Subject: Objection re DA2020/1758 for 11 Lewis Street Balgowlah Heights
Attention: Mr Kent Bull

BALGOWLAH HEIGHTS PUBLIC SCHOOL P & C
9b Lewis St, Balgowlah Heights, NSW 2093

RE: DA2020/1758 - 11 Lewis Street BALGOWLAH HEIGHTS NSW 2093

Figure 2 Morning Peak additional traffic on surrounding road network

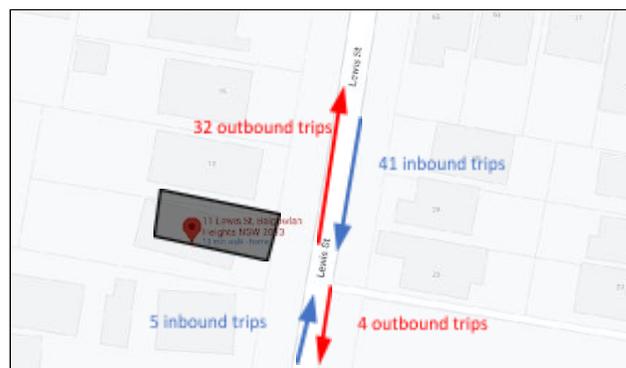
Based on the above estimation of trip generation, it is assumed that the proposed development will have a greater impact on the surrounding network than presented in the traffic assessment. Specifically, 50 ‘inbound’ trips in the morning peak (10 staff + 40 children) and 40 ‘outbound’ trips (children only), as shown in Figure 1. This calculation is significantly in excess of the 46 vehicle movements estimated as part of the development application.

The traffic assessment assumes that 10% of children attending the proposed childcare facility have siblings attending Balgowlah Heights Public School, consequently reducing the ‘additional’ traffic generated by the proposed development, as these vehicles would already be using the network to access the school. Based on this assumption, this would result in 46 inbound trips (10 staff + 36 children) and 36 outbound trips (children only). As shown below in Figure 2.

This calculation is still in excess of the estimated vehicle movements (and associated calculations on the intersection) estimated as part of the development application.

Figure 3 Morning peak site access movements

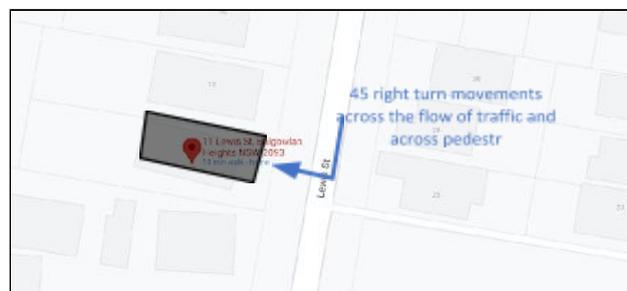
Based on the assumed traffic distribution⁷, 90% of vehicles accessing the site would travel southbound from Ernest St along Lewis St. This would necessitate a right-turn movement across both the north-bound traffic (leaving the 'kiss and drop' zone') and the heavy pedestrian movement south-bound along Lewis St to access the proposed site. Based on calculations above, this would result in 45 right turn movements, shown below in Figure 3.

In an environment of congestion, traffic queues and generally unsafe behaviour, the addition of 45 right turn movements across the general flow of traffic and heavy pedestrian movement is considered to further exacerbate an already unsafe situation.
